To: T10 Technical Committee  
From: Tim Symons, PMC-Sierra (Tim\_Symons@pmc-sierra.com)  
Date: 5 September 2008  
Subject: 08-360r1 SAS-2 ZONE GROUP VALID bit

sas2r14d Serial Attached SCSI – 2 (SAS-2) revision 14d

**Figure 56 – Zoning expander route table**

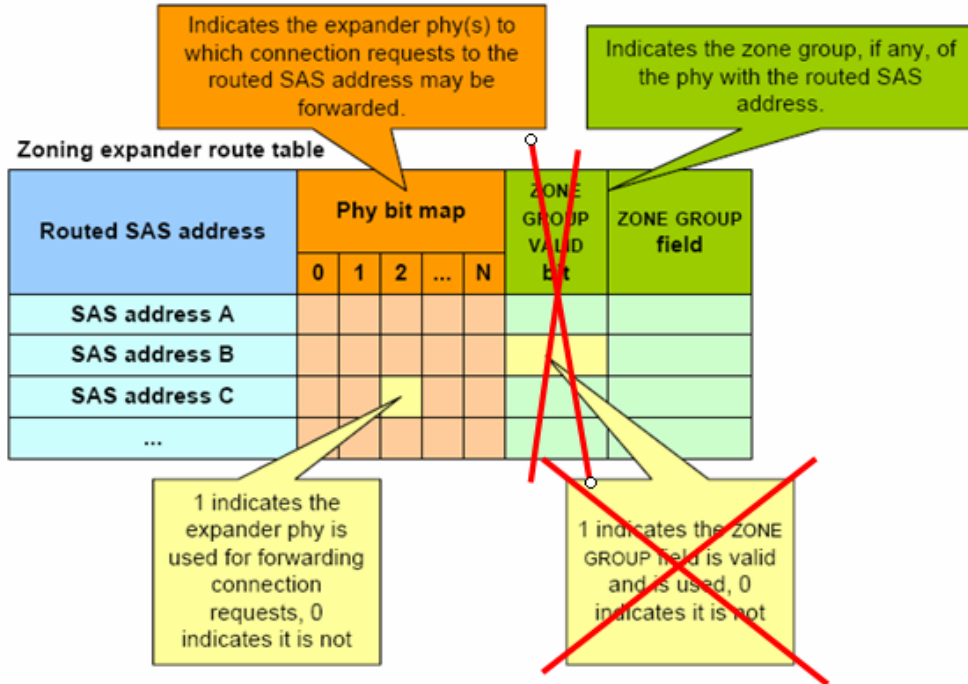
Other references for the ZONE GROUP VALID bit are in Figure 56 and Table 34 but both references are confusing and unnecessary.

**Editors note :** If zoning is enabled then the ZONE GROUP field is valid else it is not.
